November 12, 2020

Subject: Public Space Permit Application No. 358240: 8x10 foot garden shed in the public parking adjacent to lot 803, in square 1068SE (205 15th Street, NE)

Figure 1. Survey, 205 15th Street, NE, Square 1068SE, lot 803, and parking. Proposed accessory building is not to scale.

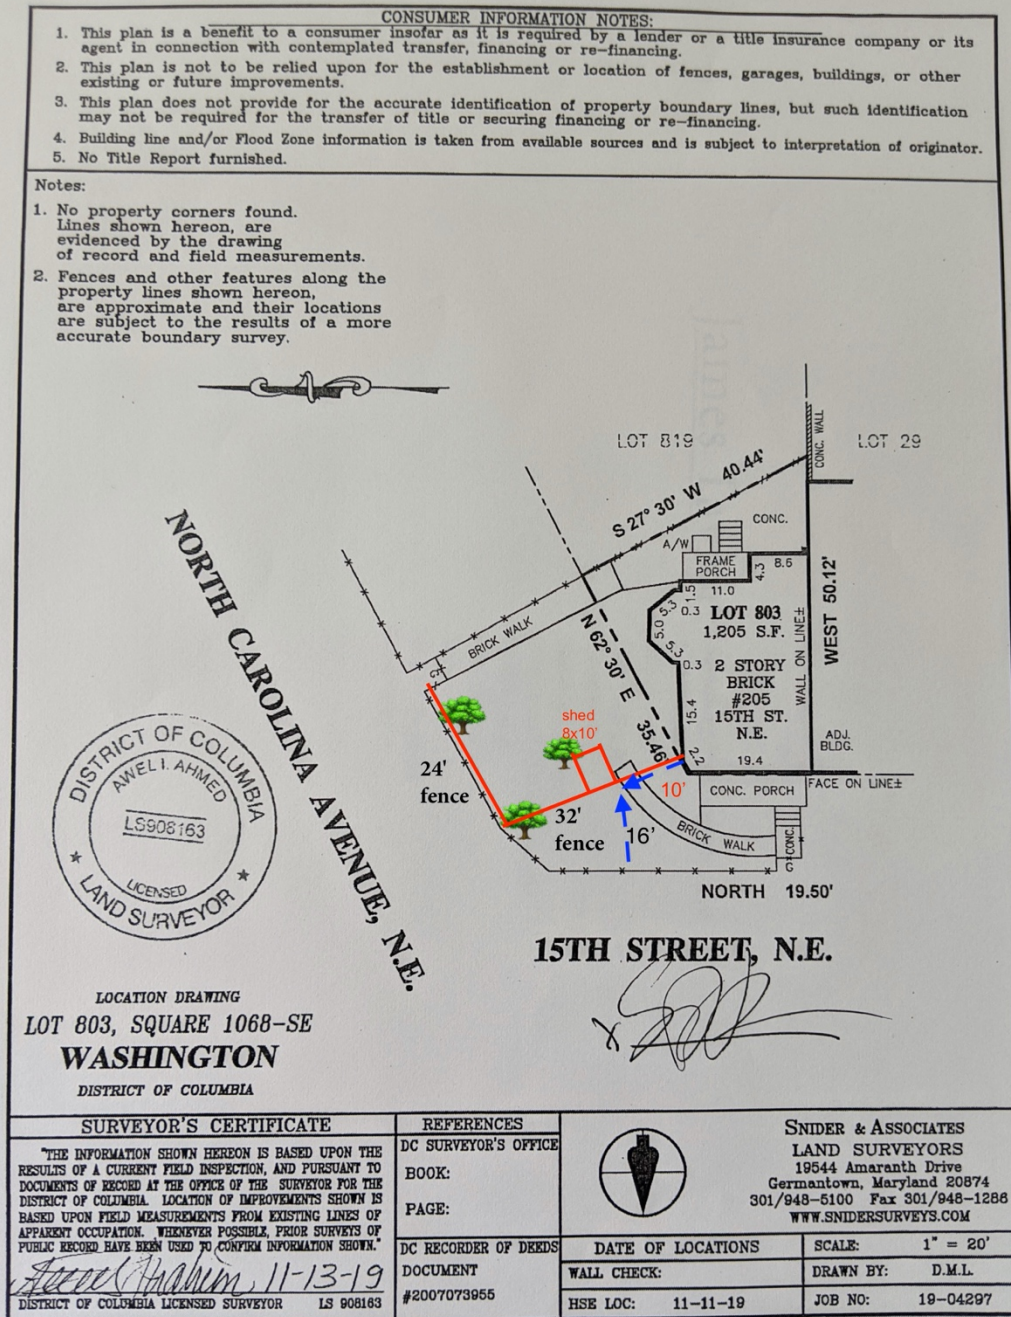
CHRS opposes the application of Sunny K. Petzinger, seeking permission to erect an accessory building (garden shed) in the public parking adjacent to lot 803, in square 1068SE (205 15th Street, NE). See Figures 1, 2. The dimensions of the building are 8 x 10 feet, and, according to Ms. Petzinger's statement to the ANC 6A Transportation and Public Space Committee, the building would approximately 7 feet tall at the highest point on its gable roof.

1. An accessory building is not an architectural projection from an existing structure (such as a bay, porch or window well) and is therefore not included in the list of permissible exceptions.
2. Furthermore, the building would occupy a significant portion of the parking and would block the view of additional greenspace, undermining the goal of a visible park.
3. Finally, approval of this application would open the door to innumerable future similar structures which would further erode public parking, city-wide.
